Service Information Bulletin

****Notice of Recall 08V-290****

Subject: Gearbox Replacement

Model: R 1200 GS facelift (K25/11), R 1200 GS Adventure facelift (K25/12) and R 1200 R (K27)

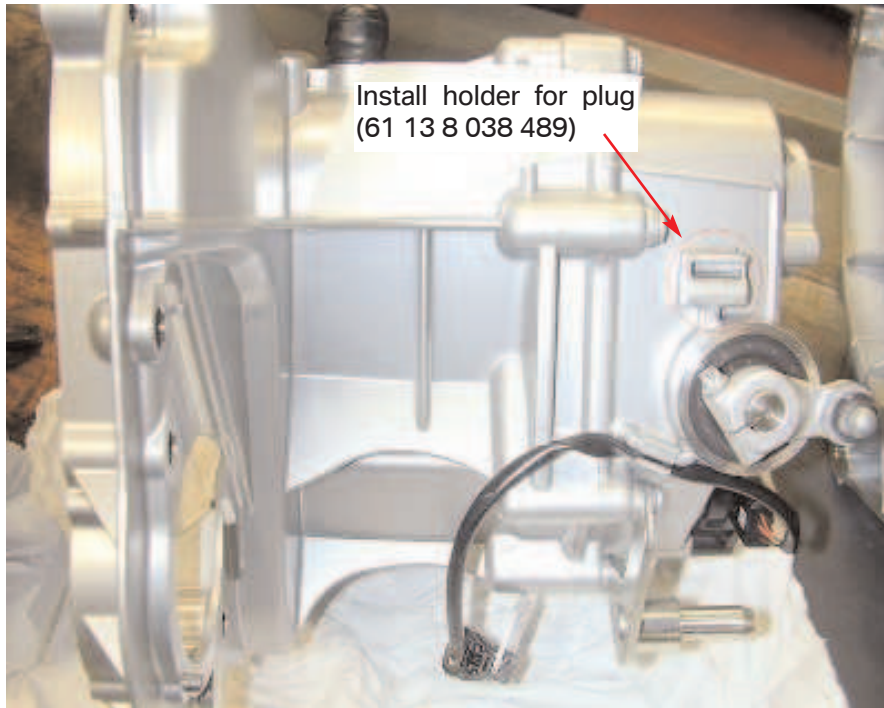
Aftersales Solution: All affected motorcycles must have the gearbox replaced. All new gearboxes are shipped dry, in other words without oil filling, and must be filled with oil before the motorcycles are used for the first time.
The gearboxes shipped from the factory are of the most recent design and incorporate modifications to the holder of the top cable guide of the gearbox potentiometer, so it important to take the following into account:
The clip from the original gearbox can be re-used for the **bottom guide** of the gearbox-potentiometer cable.
In regards to the **top cable guide**, it is **not** possible to re-use the clip from the original gearbox. If no clip is enclosed with the replacement gearbox, the clip holder for plug (part number 61 13 8 038 489) has to be ordered from the electronic parts catalogue and installed. See photo of cable routing.
